## CALIFORNIA COASTAL COMMISSION

REGULAR CALENDAR  
STAFF REPORT AND PRELIMINARY RECOMMENDATION

Application No.: 6-00-110

Description: Grade and widen portion of roadway which serves as access for existing treatment plant and public tidepool; also proposed is installation of 3-inch asphalt overlay and berm along entire length of roadway (approx. 7,220 lineal feet), extension of existing guard rail for approximately 150 linear feet and installation of drainage improvements at existing culverts.

EXHIBIT NO. 4
APPLICATION NO.
<b>6-00-110</b>
Location of Storm Drains on South Access Road
 California Coastal Commission

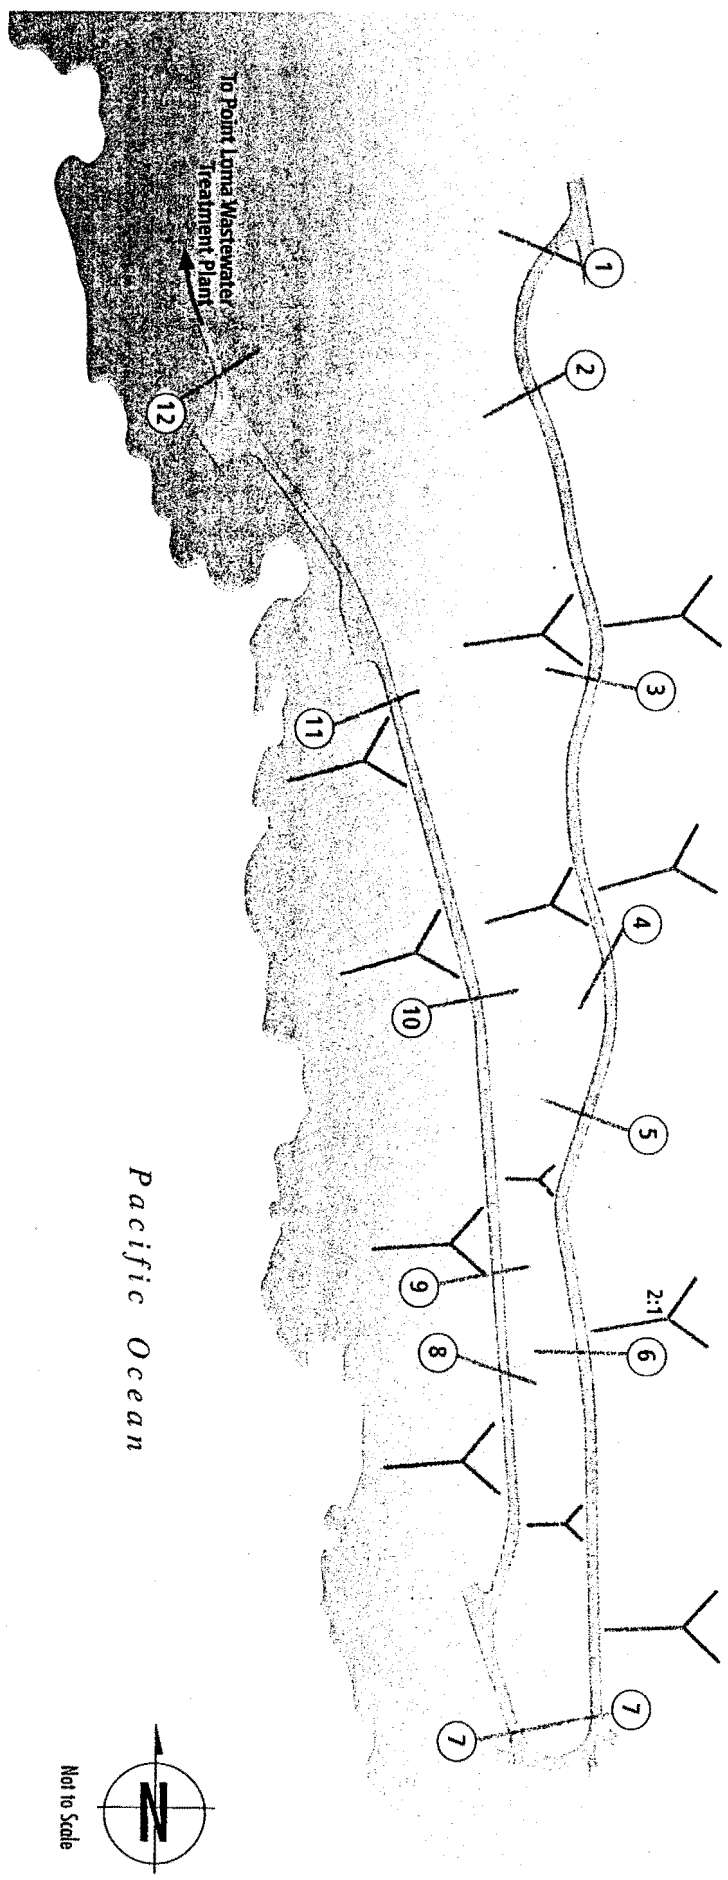
The subject access road is a federal road that is on Navy property. It provides access to the Cabrillo National Monument (tidepools) as well as to the treatment plant itself. However, because it is not a City-owned road, it is not part of a regularly scheduled maintenance program (i.e., sweeping program, etc.). Nevertheless, the City does have an agreement with the Navy to maintain the road; thus, the proposed improvements are proposed as a means to do so. In addition, the City has indicated that there are a total of 12 existing storm drains which cross the access road (reference Exhibit No. 4). However,

11 of these have outlets discharge (with dissipation) into the natural vegetation and/or soil areas which provide natural filtration to reduce the amount of contaminants that might impact water quality. Storm drain No. 7 is the only storm drain that crosses the road in two locations (in the vicinity of the hairpin turn) and which discharges directly to the ocean. Rip rap exists at the outlet of the drainage pipe which provides some filtering of the storm water to improve water quality at these locations. The City considered the possibility of installing a filter at the outlet of this drain. But these filters tend to get plugged which results in water and sediment backing up into the pipe which can also cause damage to the roadway. This would result in ongoing maintenance which is difficult for the City to perform. However, the City is proposing to install filters at three inlets that feed into this storm drain. The filters will be placed at the curb inlet on the inland side of the roadbed north of the hairpin turn, at the grate inlet at the outside of the roadbed north of the hairpin turn and along the side inlet on the inland side of the road just past the hairpin turn (reference Exhibit No. 5). This will dissipate debris and sediment and will filter all the contaminants off the road in that area. This will also be easier for the City to maintain.

EXHIBIT NO. 5
APPLICATION NO. <b>6-00-110</b>
Storm Drain Profile
California Coastal Commission

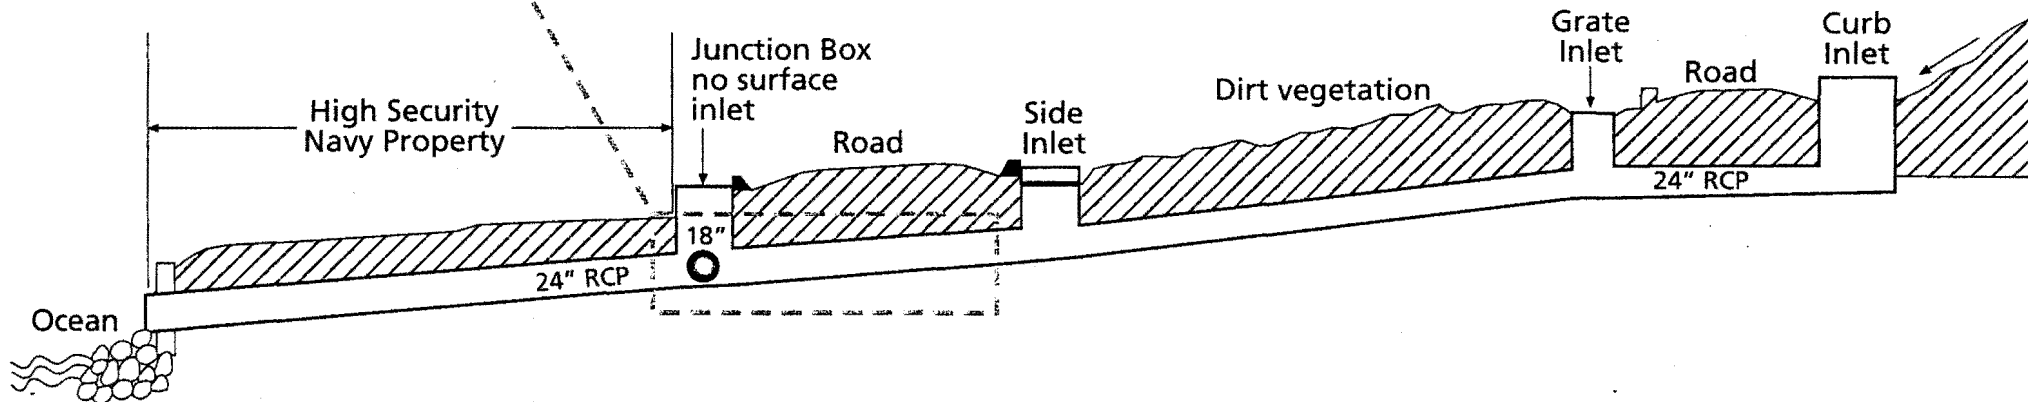
- (a) Permanent structural or non-structural treatment control best management practices (BMPs) effective at removing and/or mitigating pollutants of concern, specifically, petroleum hydrocarbons, heavy metals, sediment and particulates. Selected BMPs (or suites of BMPs) shall be designed to treat, infiltrate or filter stormwater from each runoff event, up to and including the 85<sup>th</sup> percentile, 24-hour runoff event for volume-based BMPs, and/or the 85<sup>th</sup> percentile, 1-hour runoff event, with an appropriate safety factor, for flow-based BMPs. These requirements apply specifically to the City's proposal to install three filtering devices at Storm Drain #7. The filters will be placed at the curb inlet on the inland side of the roadbed north of the hairpin turn, at the grate inlet at the outside of the roadbed north of the hairpin turn and along the side inlet on the inland side of the road just past the hairpin turn (reference Exhibit No. 5).
